Product Change Notification - RMES-02PWOV621

CCB 3832 Initial Notice: Qualification of MTAI as a new final test site for selected products of the 0.25 um wafer technology available in 32L PDIP (0.600 in) package.

PCN #: RMES-02PWOV621

Box information

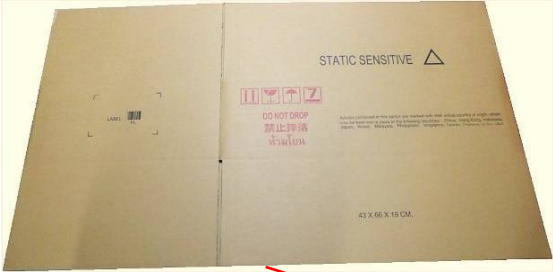
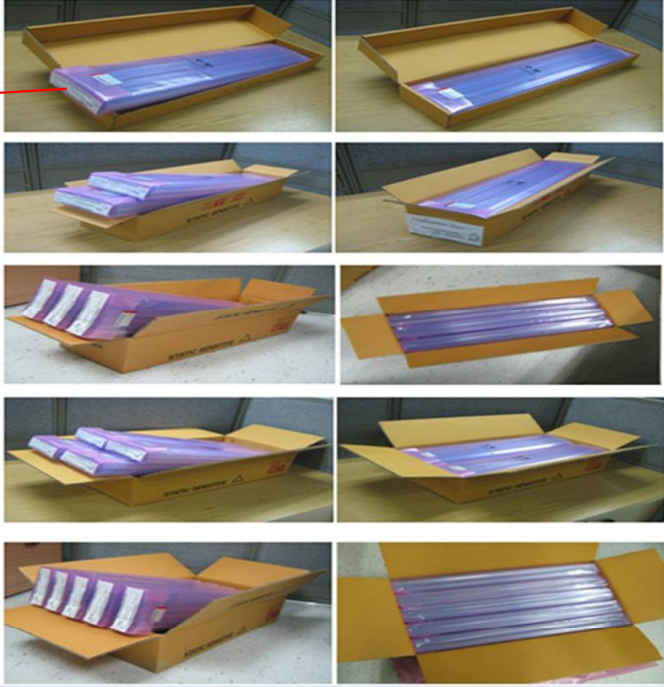
| | KYE | MTAI |
|---|--|---------------------------------|
| Box | With inner box and outer carton (see slide 3) | Inner box only (see slide 3) |

| PRE CHANGE (KYE) | POST CHANGE (MTAI) |
|--|--|
|  <p data-bbox="500 877 766 919">Pink ESD Bag</p>  <p data-bbox="526 1031 711 1073">Inner box</p> <p data-bbox="451 1556 699 1598">Outer carton</p> |  <p data-bbox="1101 1535 1349 1577">Inner box only</p> |
